SERVICE BULLETIN

M-925

March 25, 1986

HANDLEBAR SWITCHES

Figure 1. Handlebar Switch Housings

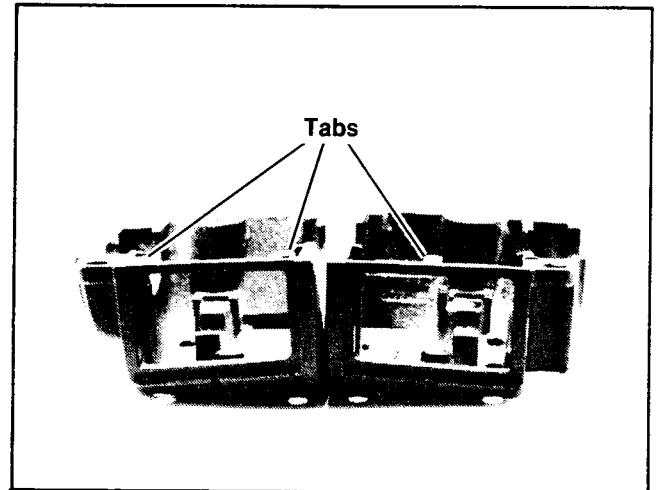
Refer to Figure 1. 1982 to 1985 handlebar switches had locating tabs, on one half of the switch housing, which fit into indents or slots in the mating half of the switch housing. Beginning with 1986 models, the housings no longer have the tabs or slots in the switch housing contact surfaces.

Stock switch housings for repair parts orders presently have the tabs. When fitting a switch housing, (parts order stock) that has the tabs, to a switch housing that no longer has the slots, (current production vehicles), it will be necessary to grind or file the tabs flush with the base surface prior to assembly.
